EEG-83

IDENTIFICATION OF ISSUES RELEVANT TO THE FIRST RECERTIFICATION OF WIPP

Environmental Evaluation Group
New Mexico

September 2002

Figure 2
 Potash Resources In the Vicinity of WIPP

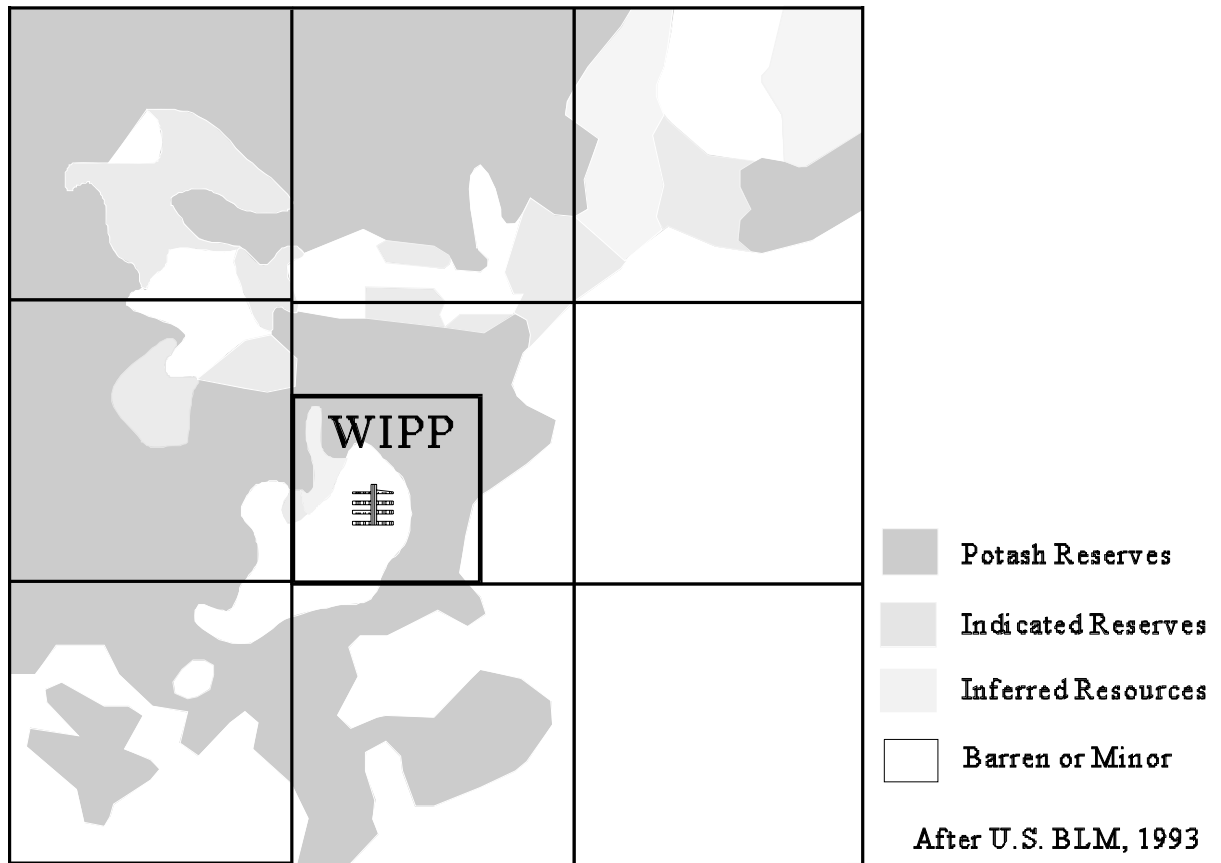
Consideration of solution mining for extraction of minerals is the natural progression of alternatives in the life of a mine. Companies which mine various commodities, including potash, consider solution mining following the extraction of higher grade ores through more predictable traditional methods. In addition, ores which were once considered as too low grade become economical with the refinement of new technologies. With this in mind, it is reasonable to assume that solution mining will be considered in the vicinity of the WIPP project for extraction of minerals (NMBMMR 1995). This is especially true since the U.S. Bureau of Land Management has delayed development of oil and gas reserves surrounding the WIPP in favor of prioritizing the extraction of potash. The prioritization policy will push forward in time a decision by potash companies concerning final development of potash reserves. Figure 2 shows the potash reserves and resources in the vicinity of the WIPP.

Solution mining, whether for extraction of resources or for excavation of underground storage, should be considered. Plausible scenarios related to this activity should be evaluated and screened for each recertification as technology in this area continues to be refined.

Figure 4
 Culebra Head (ft) Difference
 CCA to 2001

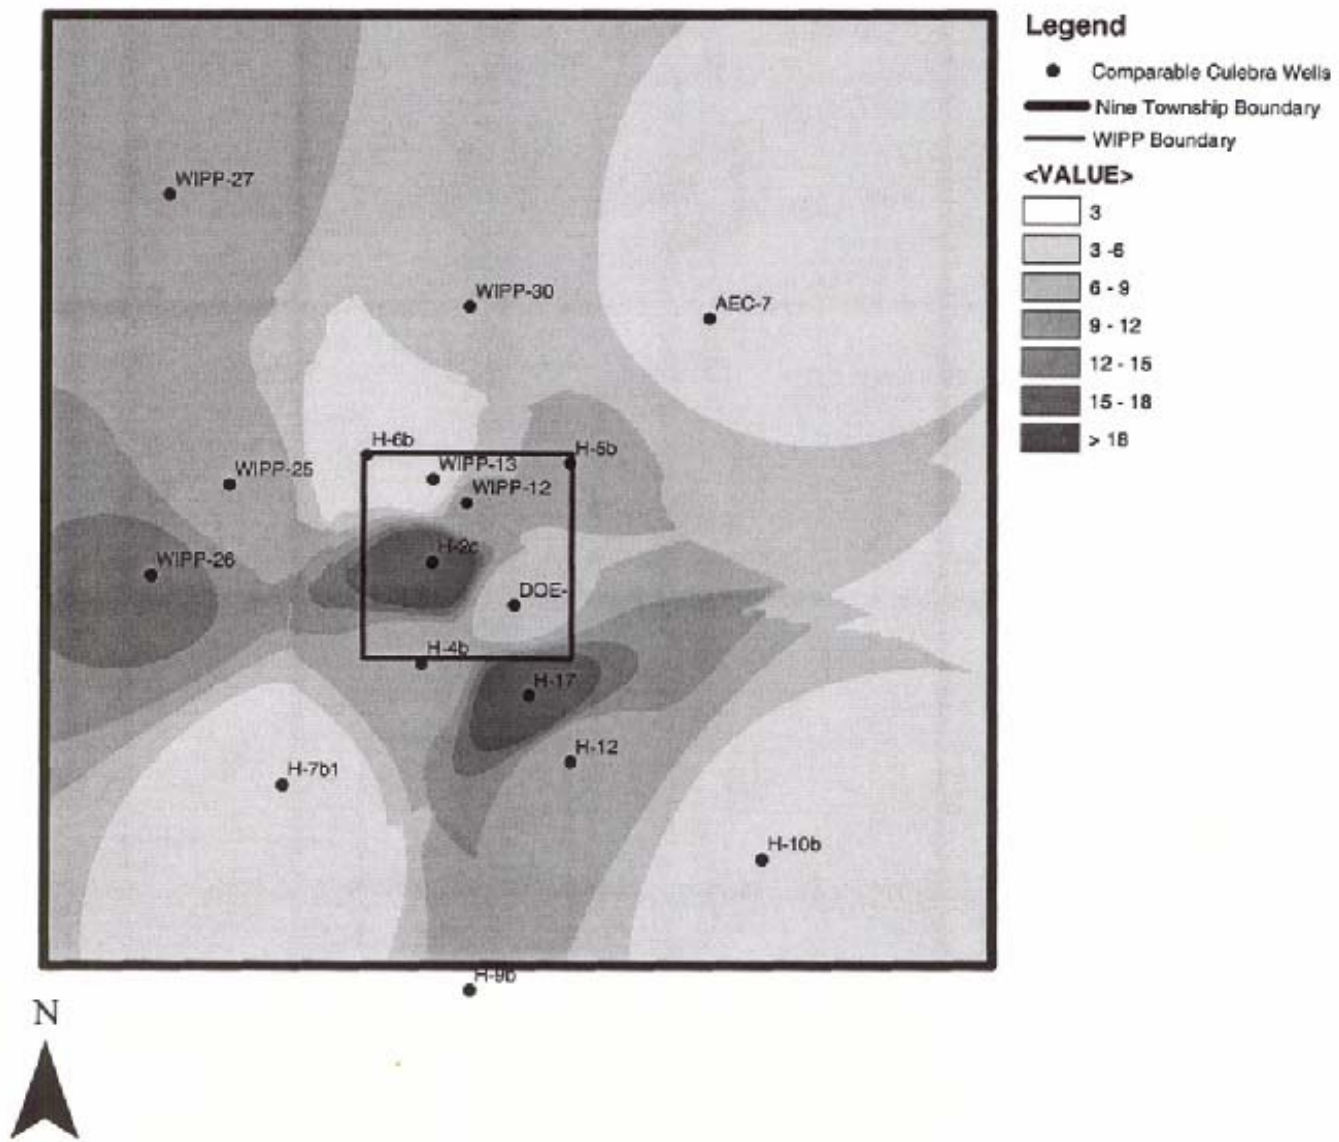
These increases are of concern in the recertification because 21 of 28 monitoring wells now show water elevations in the Culebra aquifer outside the ranges used for calibration of the CCA transmissivity fields. This may cast doubt on the validity of the steady-state flow model used in the CCA. Also, the reliability of the transmissivity estimates were determined using inverse methods that assumed the Culebra was a non-leaky, two-dimensional aquifer. Increasing water elevations suggest a likely connection of the Culebra with other water-bearing units, raising questions concerning the validity of this assumption as well.

During January 2002, the DOE convened a workshop to address the issues of the water level rises. The stated purpose of this workshop was “to demonstrate an understanding of the WIPP hydrologic system by developing scenarios that account for the observed changes and show that the CCA modeling results remain valid for recertification” (Beauheim 2002). Figure 4 shows the difference in water elevations between the time of the CCA and 2001.

conceptual model. Until a source is determined for the water level increases, the validity of the Culebra conceptual model remains in question.

Figure 5

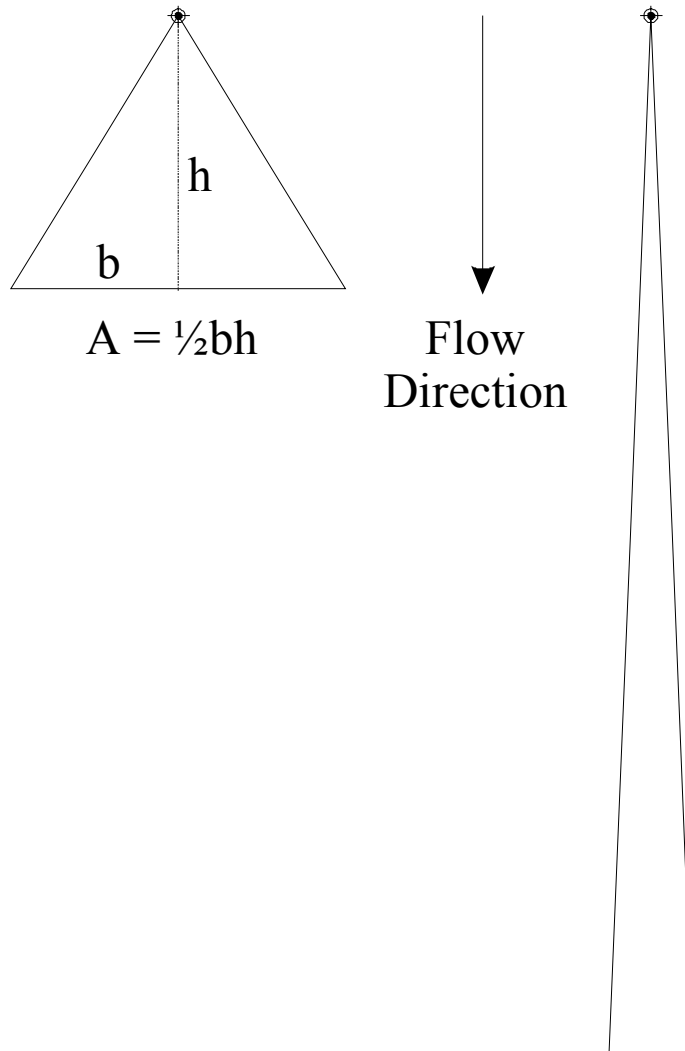
During development of the CCA, several modeling errors were identified which resulted in an artificial spreading in the calculated width of a potential contaminant plume at the expense of its length. This would result in non-conservative travel times to the regulatory boundary. These errors included numerical dispersion and spatial truncation errors in the transport code, poor resolution from using a grid that was too coarse for the scale of the problem, and overestimation of the size of the solute source area (Konikow 1997). These errors are especially apparent in a heterogeneous aquifer such as the Culebra. If a plume spread out laterally due to numerical dispersion, the wider plume will move downgradient a shorter distance than would be the case if a finer grid were used during modeling (Figure 5).

However, the DOE now plans to retain the SECO models for recertification (Knowles 2002), despite the previously identified problems. In addition, the DOE research on transport in the Culebra showed a superior fit of experimental data with a multi-rate diffusion code such as STAMMT-L (Altman and Meigs 1999). The EEG encourages DOE to reconsider its decision and to implement the previously planned changes to the Culebra models.
